LEE'S SUMMIT
MISSOURI
Development Services Department

Development Services Staff Report

File Number	PL2024-117 – PRELIMINARY DEVELOPMENT PLAN – Diventures
Applicant	Diventures
Location	2951 NE Independence Ave.
Planning Commission Date	June 27, 2024
Heard by	Planning Commission and City Council
Analyst	Ian Trefren, Planner

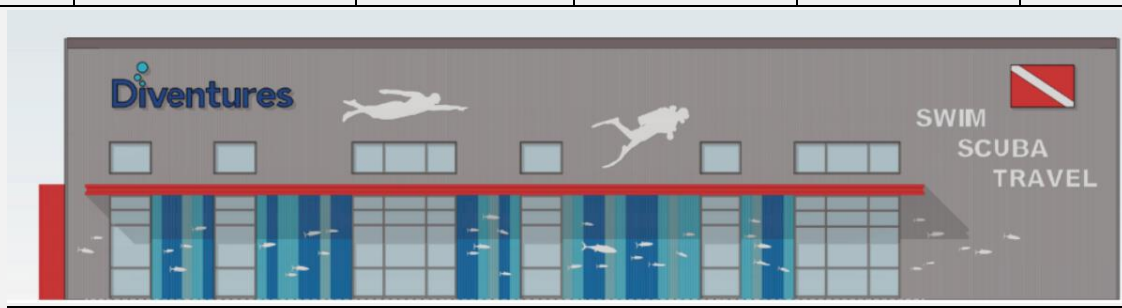
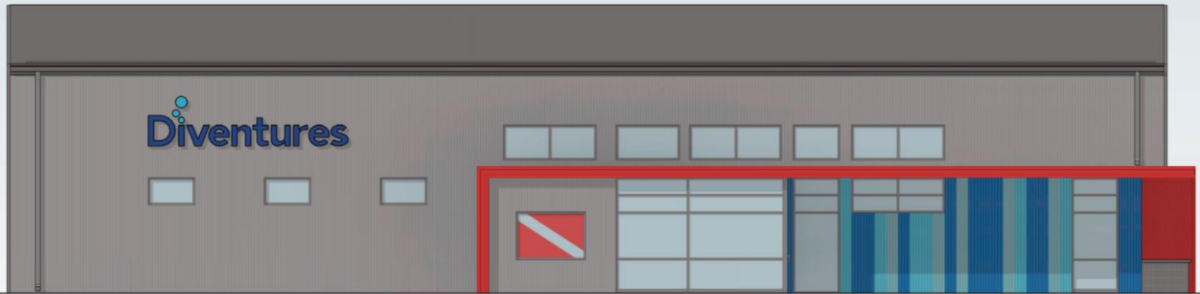
Additional Wall Sign Request

- **Required** – A single tenant building is allowed three (3) walls signs.
- **Proposed** – The applicant has nine (9) total wall signs as shown on the Signage Analysis document, an increase of one from the previously approved application.
- **Recommendation** – The request for additional wall signage is not out of place for this type of commercial business. Many restaurants and retailers have more than the number of signs allowed by right. In this case, the subject site will have visibility to I-470 on the east and south sides of the building. The north and west sides of the building will be visible from NE Strother Rd. Staff believes the proposed nine (9) wall signs are compatible for the area, proportional for the building and provides a reasonable means of identification for the tenant space.

The increase in sign count from the previously approved PDP is caused by the addition of a “Diventures” sign to the south façade. The proposed signage meets all other UDO requirements related to signage, included maximum letter height, lighting, and sign area.

1. A modification to the required 20' parking lot setback shall be granted, to allow for a 13' parking lot setback on the side (eastern) property line adjacent to the I-470 MoDOT right of way.
2. Nine (9) total attached wall signs shall be approved as shown on the Sign Analysis, received May 28, 2024.
3. Development shall be in accordance with the preliminary development plan received May 28, 2024.

Proposed Design Rendering

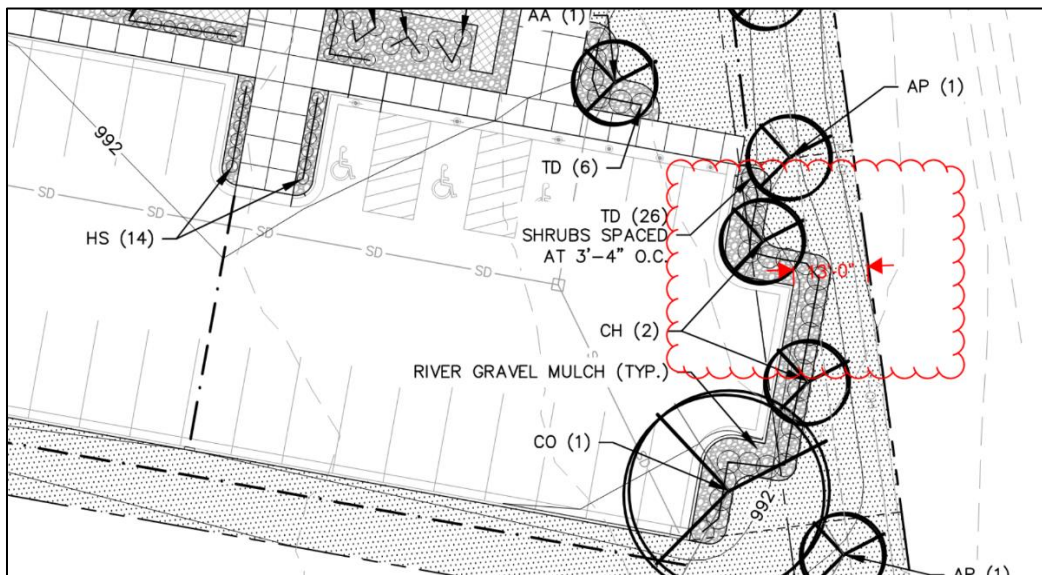
Building Materials. Proposed materials.

The applicant is seeking approval to use concealed-fastener metal paneling in six color swatches. The proposed metal panel system is the Tech Four product produced by Varco Pruden. The substantial change in metal composition and architectural style necessitated the re-approval of the design via preliminary development plan. The proposed building materials are compatible with the design and construction of existing commercial and industrial buildings in the surrounding developments, particularly the K1 Speed building located to the south of the subject property.
